RE: ENGINEER CERTIFICATION FOR LOT 12-B BLOCK 8 REBONITO SUBD. (J23-D24)  
CERTIFICATION STATEMENT DATED 1/22/98

RE: REVISED DRAINAGE PLAN FOR LOT 12-B REBONITO SUBDIVISION (J23-D24)  
ENGINEER'S STAMP DATED 4/28/97

#### LOTS 12A & 12B BLOCK 8, REBONITO SUBDIVISION GRADING & DRAINAGE PLAN

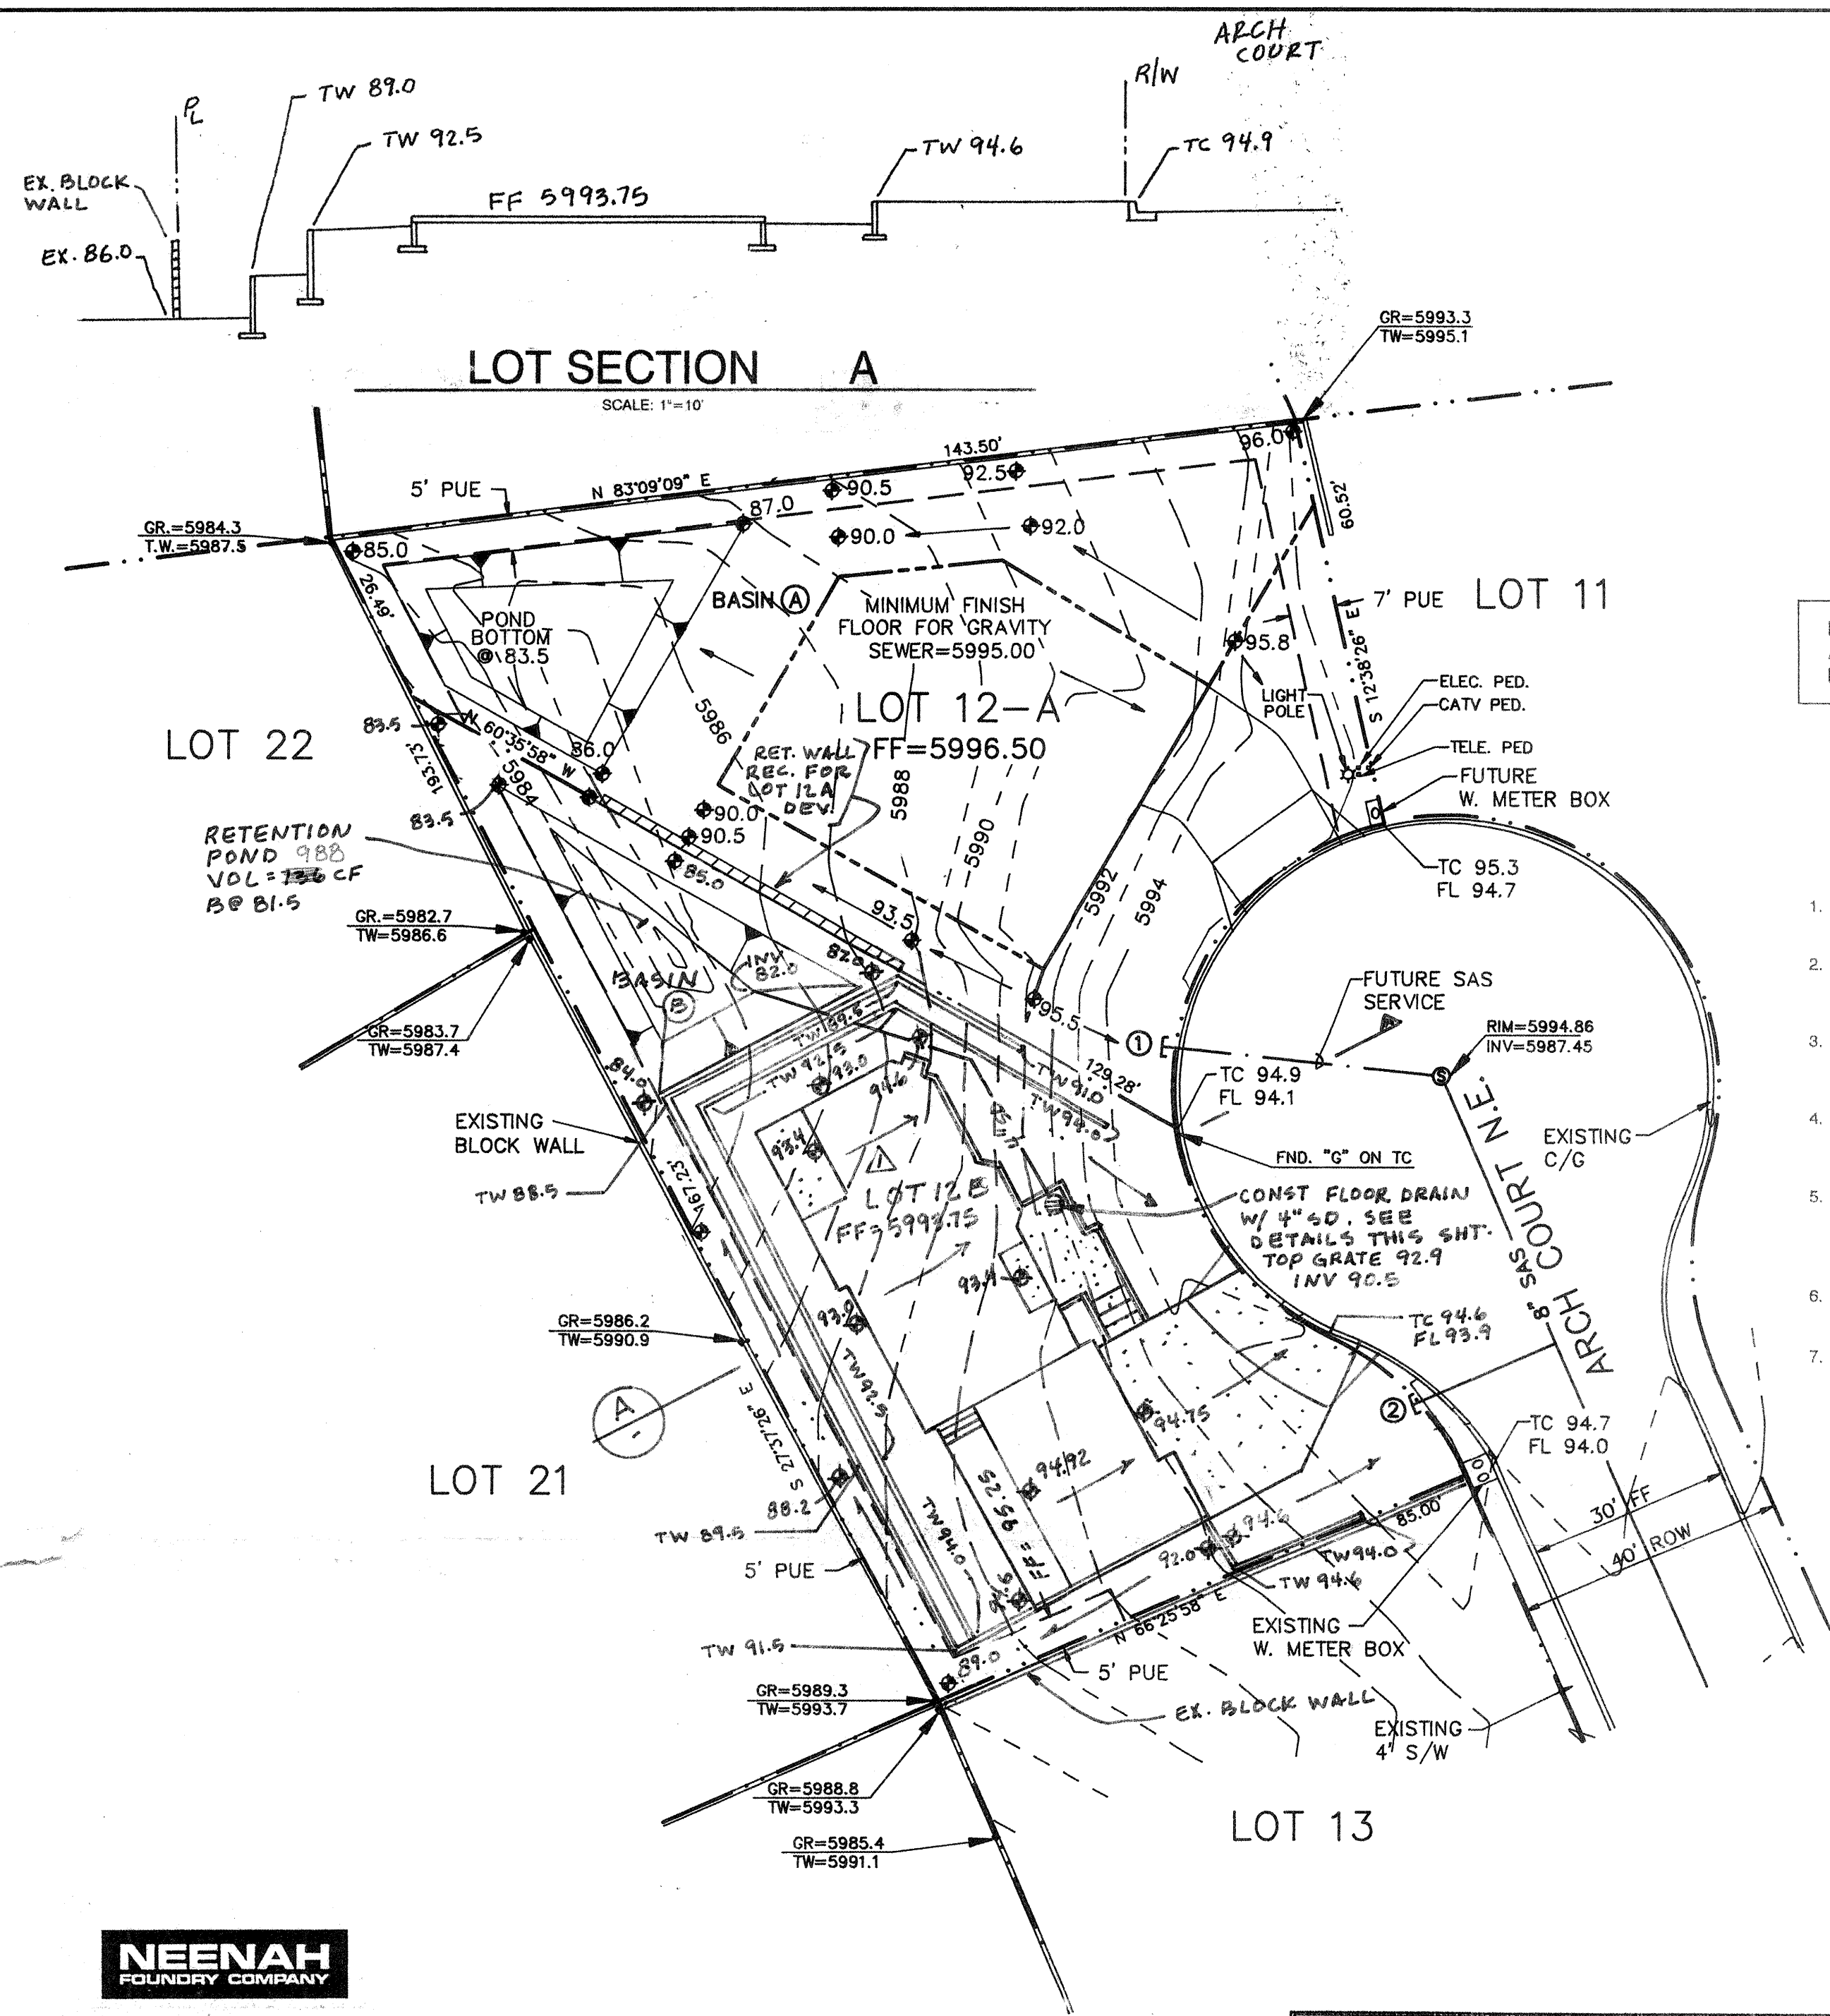
Based on the information provided on your April 29, 1997 submittal, the above referenced site is approved for Building Permit.

Please be advised that the proposed retaining walls will need to be constructed prior to continuation with the house pad. The retaining walls will need to be constructed and certified as to location by your firm. Please advise your client that a retaining wall permit is required prior to construction.

Also, prior to final acceptance by the City of Albuquerque, Engineer Certification per the DPM checklist will be required.

Please advise me as to your inspection and concurrence of the retaining walls so as to release the inspections with Code Administration.
